TO: Water Right File 51-13106

SUBJECT: Licensing Review of Water Right 51-13106

RE: Review of pump test required by condition on permit completed by SPF

STATE OF IDAHO
DEPARTMENT OF WATER RESOURCES
BENEFICIAL USE FIELD REPORT

Permit 51-13106
BUFE Aerial Map

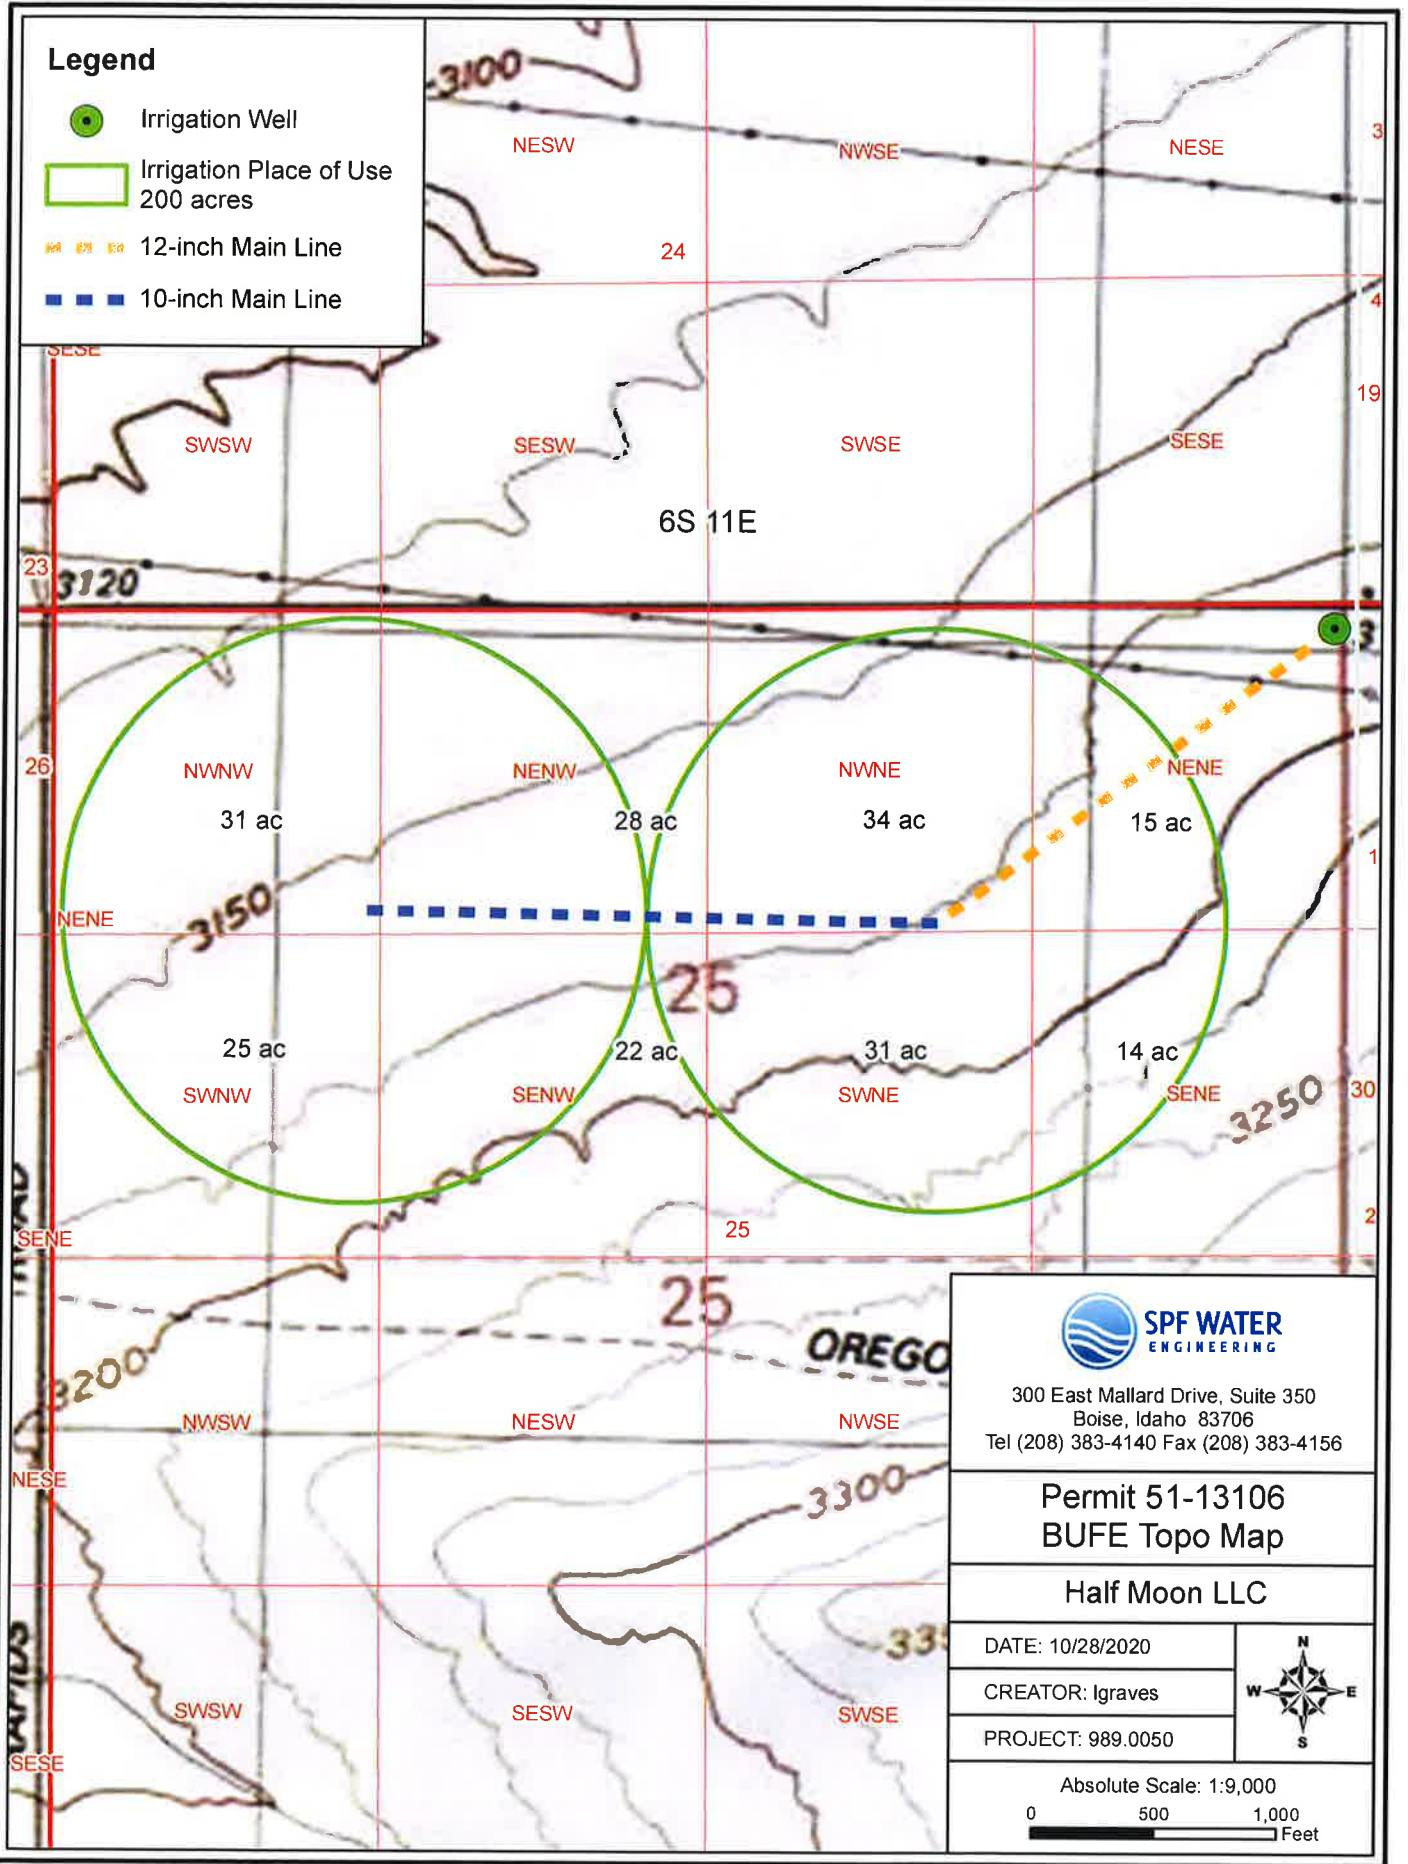
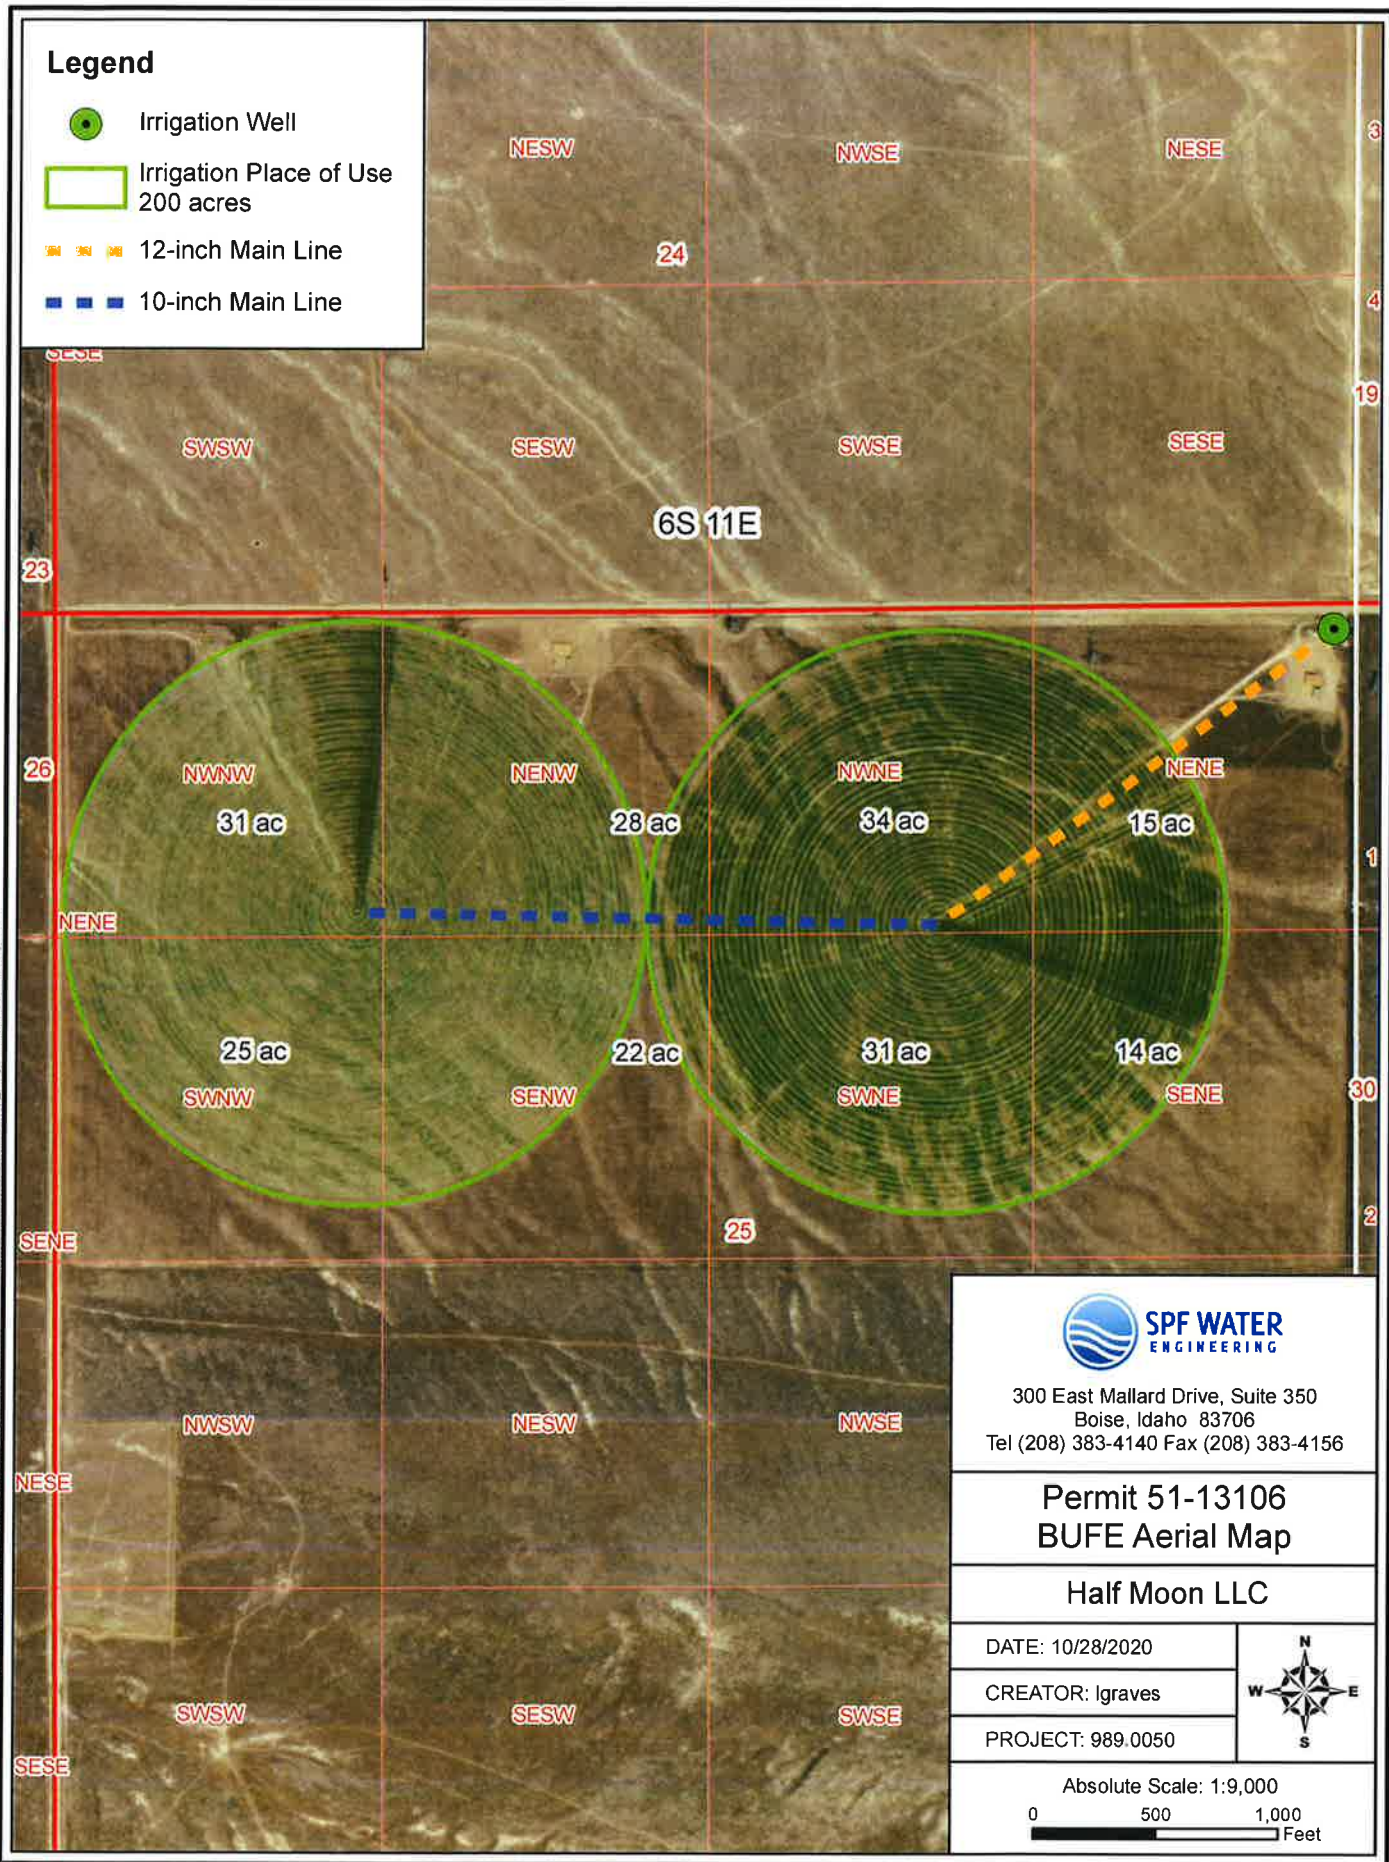
I don't have any issues with the points of diversion and places of use recommended by Mr. Scanlan. It should also be noted that the permit authorized 3 points of diversion, but the field examiner only found one point of diversion or well that is being used for irrigation. It should also be noted that only 200 acres were actually irrigated, so the permissible place of use condition should be removed at licensing. When I recreated the place of use in ArcMap, the acres per 40 acre tract varied slightly from the field examiner's acres. I used the acres found in our GIS shape, since it will be representative of the place of use in the Department's records. The difference in acres per 40 acre tract is probably due to rounding or the placement of the line. The total acreage will not change.

Half Moon Ranch Irrigation Well Pumping Test - Observation Well Data October 23 & 24, 2020

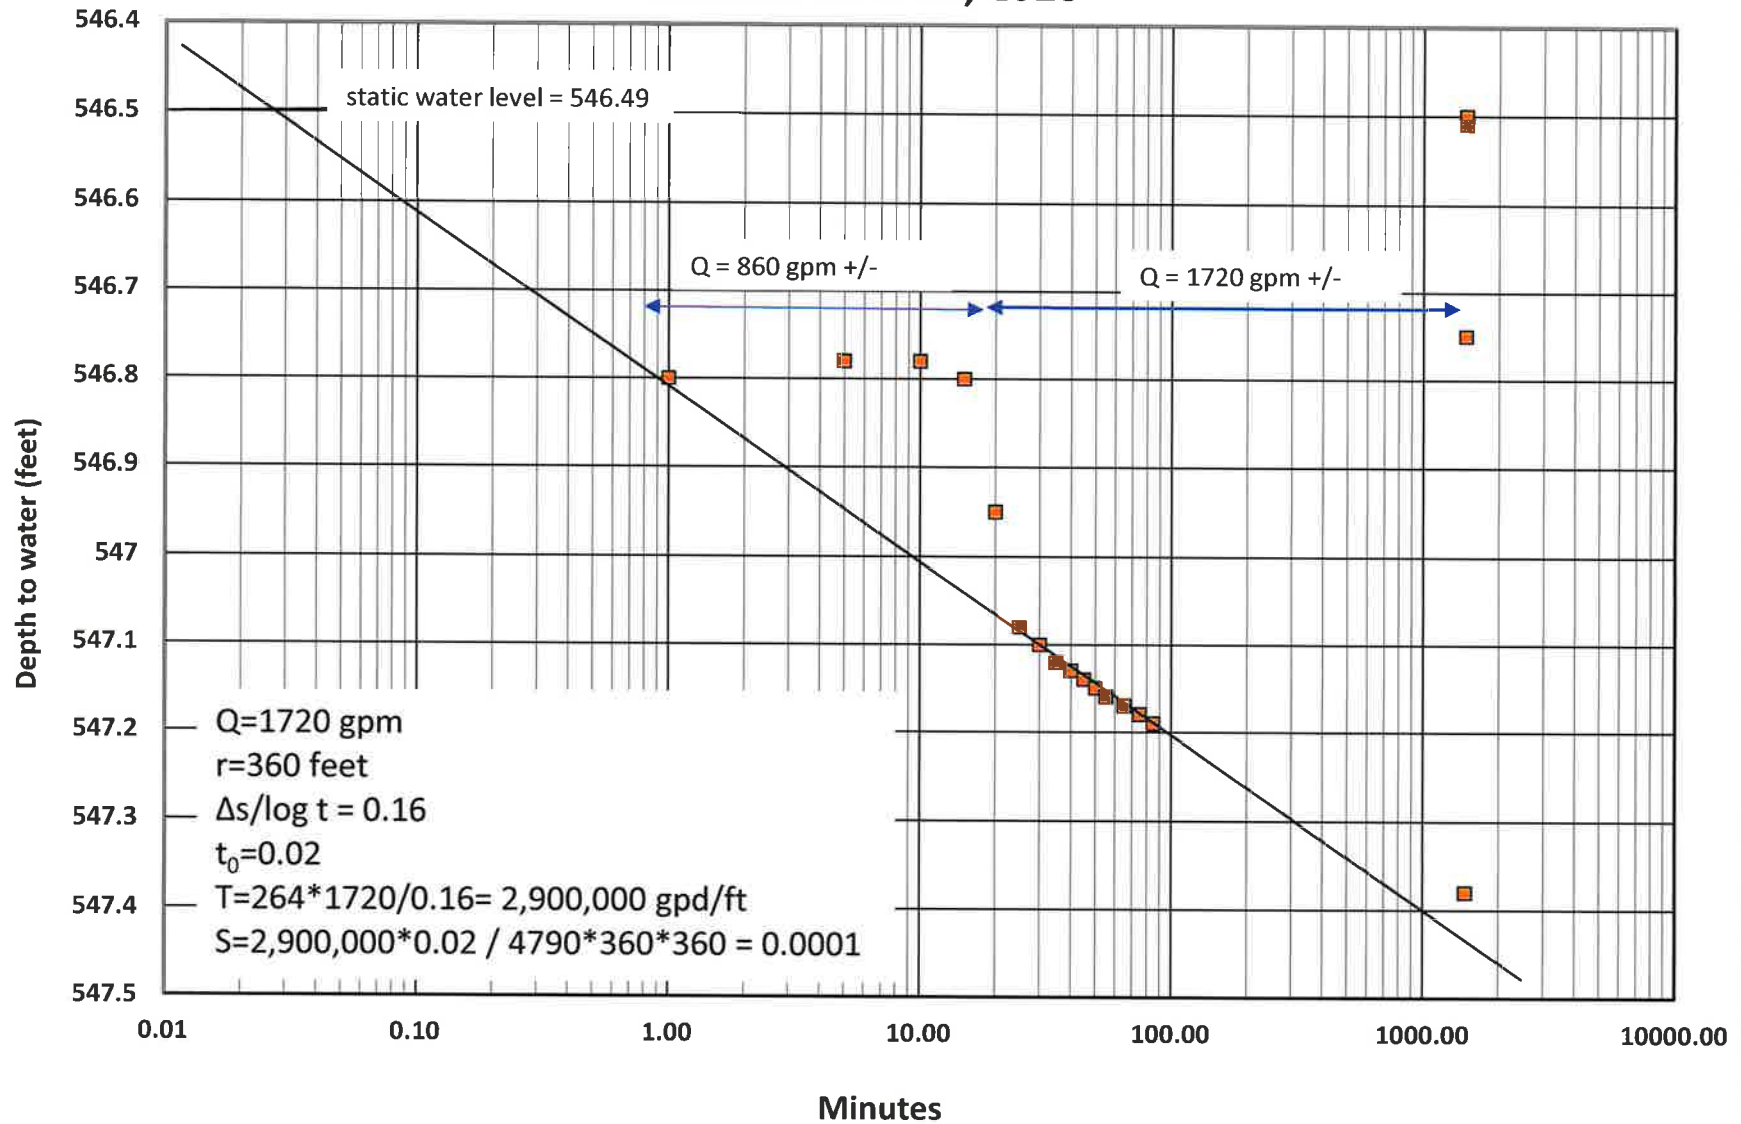
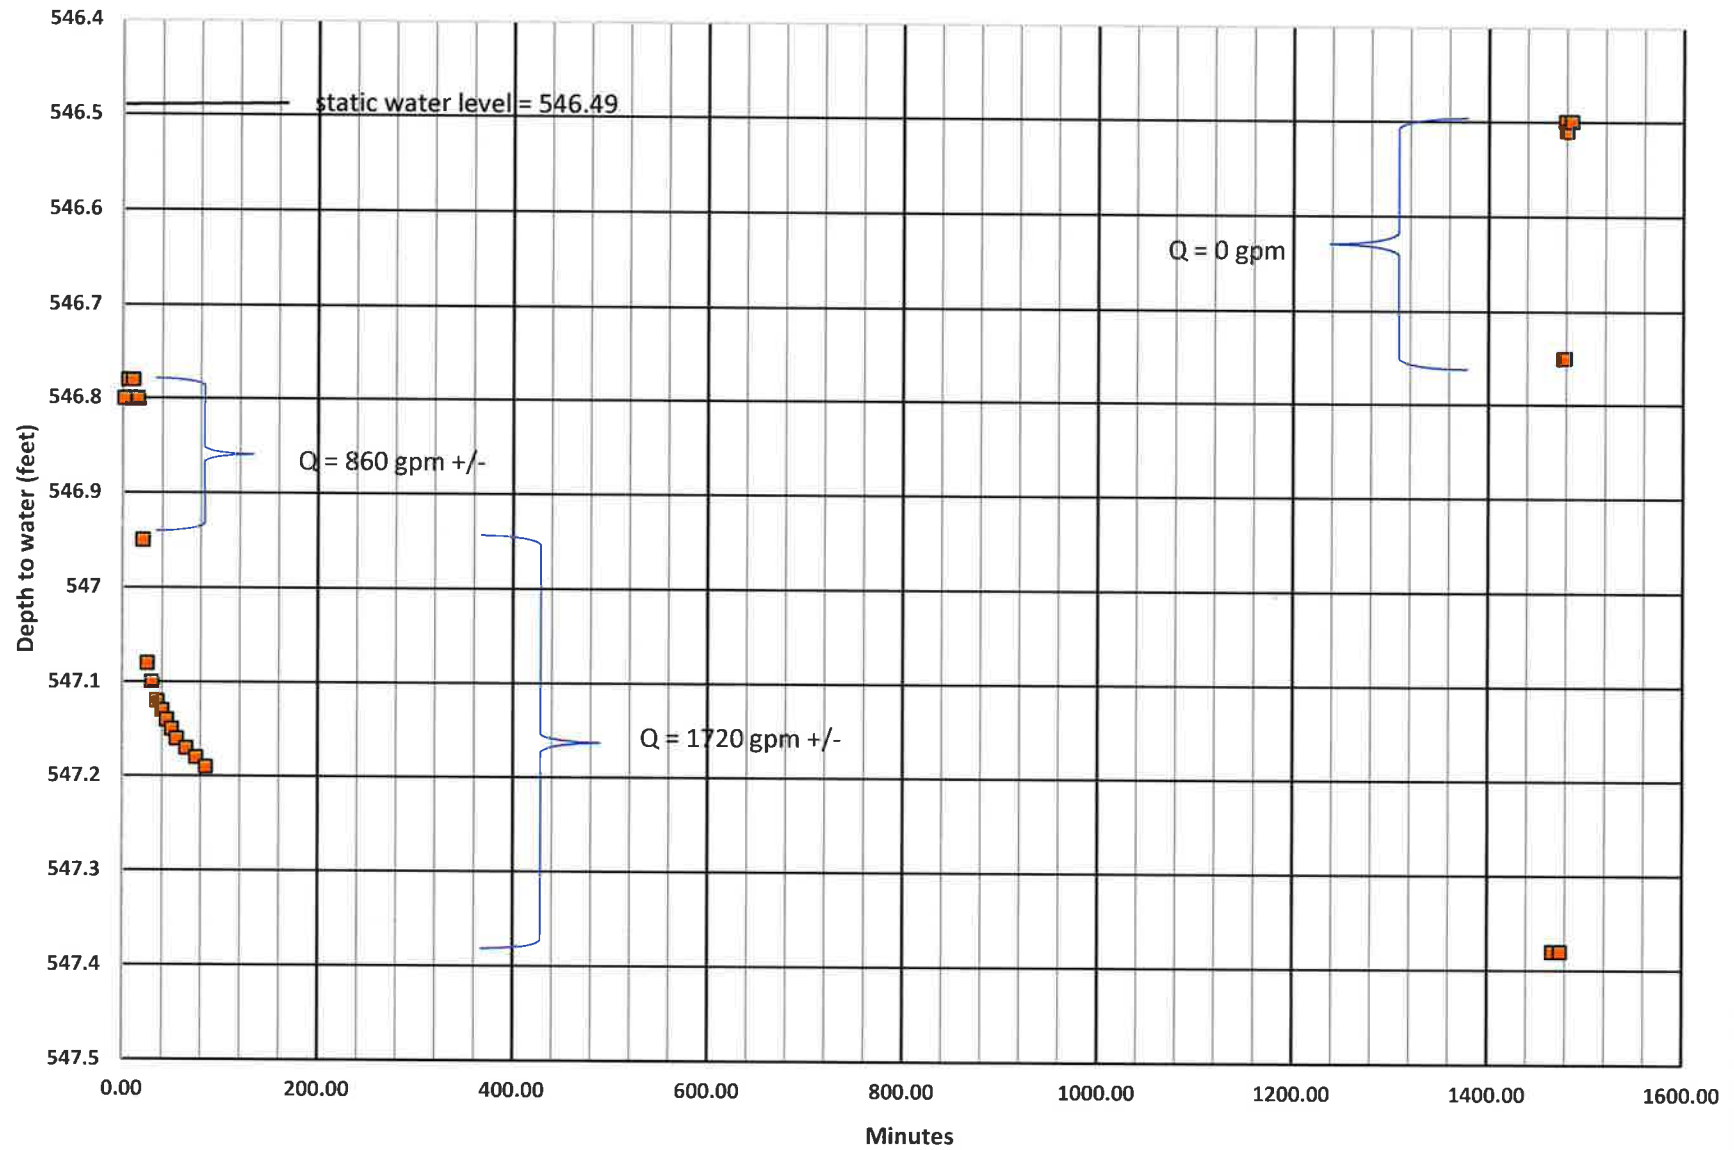
- The duration of the test meets the minimum time requirement of 24 hours (actual test duration was 24 hours and 11 minutes).
- Due to physical limitations water levels could not be measured in the pumping well, so an observation well 360 feet from the pumping well was used for water level measurements. This observation well is suitable for water level measurements as it is in close proximity to the pumping well, similar depth and a similar static water level as the pumping well (631 ft deep with a static water level of 546.5 feet). Note, that the static water level was 3.5 feet different between the two wells, but that can be attributed to ground elevation differences rather than aquifer water level differences.

- The irrigation well was in use prior to conducting the pump test. The engineer allowed the water level to recover for 3.5 hours prior to conducting the pump test. Given that the water level recovered within 10 minutes after the 24 hour pump test, the 3.5 hour waiting time was more than sufficient.

- The pumping test data allowed for the calculation of well capacity, short-term aquifer capacity, and aquifer transmissivity, which suggests that the well can produce in excess of the diversion rate authorized under this permit.
- The report provided meets the requirements of the above referenced condition of the permit.
